**Section 4.55(1A) Modification to SSD-78665709
160-172 Lord Sheffield Circuit, Penrith**

Beam Planning has prepared this application on behalf of UPG Lord Sheffield 162 Pty Ltd pursuant to section 4.55(1A) of the *Environmental Planning and Assessment Act 1979 (EP&A Act)* to modify Development Consent SSD-78665709 relating to the approved mixed-use development at 160-172 Lord Sheffield Circuit, Penrith.

Figure 2 Proposed eastern elevation

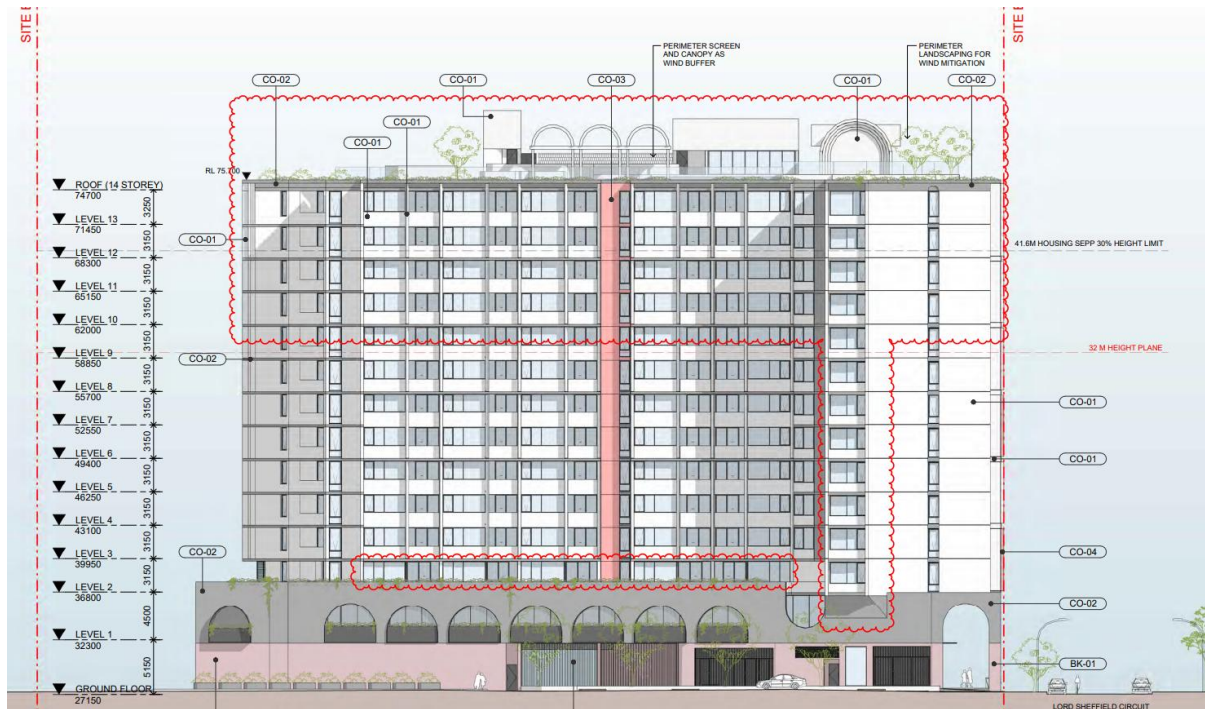
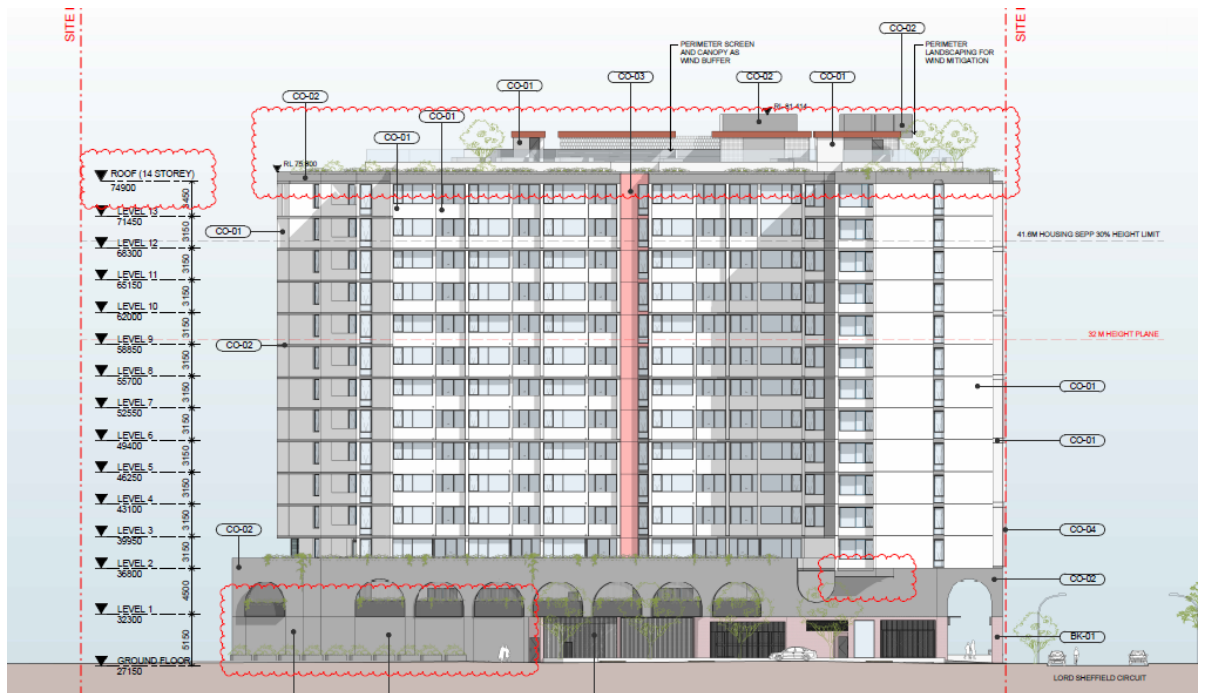
Although there is no change to the overall height of building, there is a 0.2m increase to the roof height, caused by the increased lift overrun. This change is negligible in scale, does not alter the approved overall building height and will not result in any additional visual, overshadowing or amenity impacts beyond that previously assessed.

- The amendments are minor in nature and do not alter the approved building envelope, height, massing, or architectural design intent that formed the basis of the design excellence outcome.
- The key public domain interfaces, façades, material palette, and overall architectural language remain consistent with the approved design.
- SJB Architects remain engaged as the project architect in accordance with this Condition, ensuring continuity of design integrity.
- The modifications are limited to minor functional refinements, rooftop landscape adjustments, and minor façade detailing that do not materially affect the design outcomes previously endorsed through the competitive design process and subsequent assessment.

Figure 4 Proposed rooftop plan

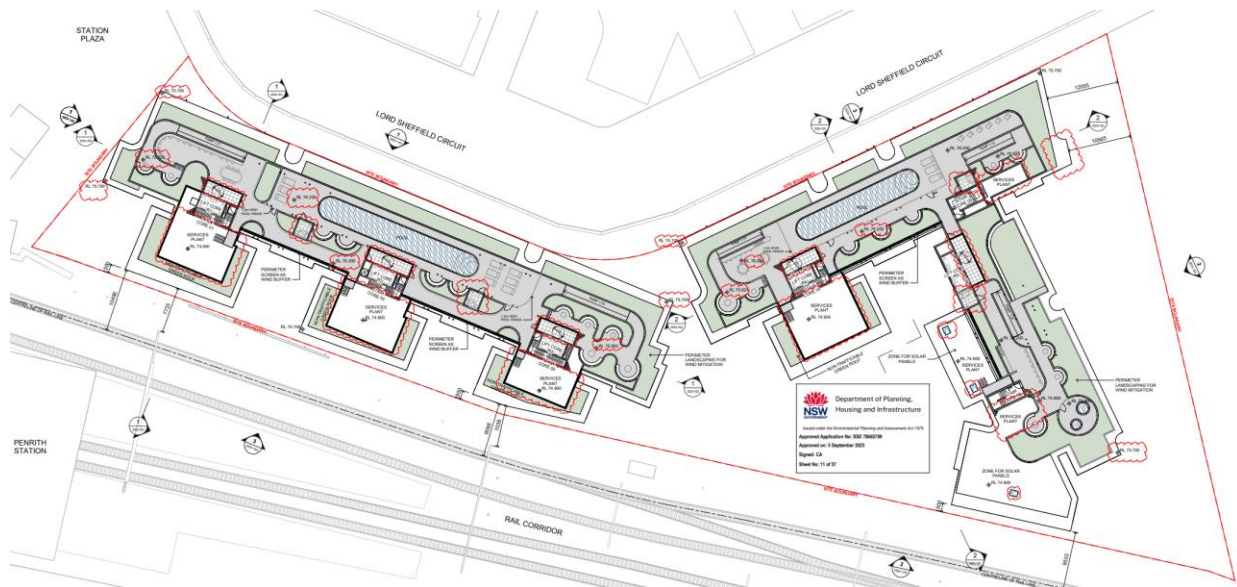
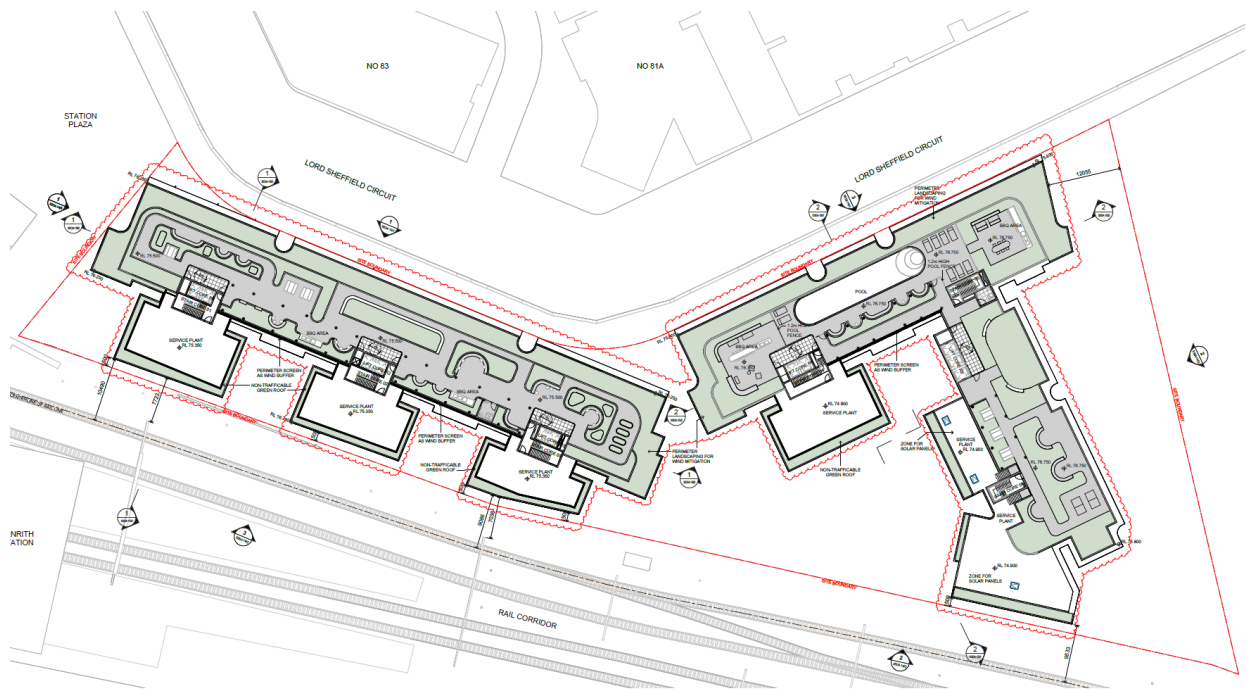
As described above, the rooftop communal area has been reconfigured due to requirements for increased service plant, and the redesign of lift cores. This has resulted in the removal of the swimming pool in Building 2. No change in the amount of communal open space is proposed, ensuring residents continue to have access to adequate amenity.

A comparison of the approved and proposed rooftop plans is included below at **Figure 3** and **Figure 4** which shows that although there is a removal of one swimming pool, this has not resulted in a decrease in communal space or usable area for residents.
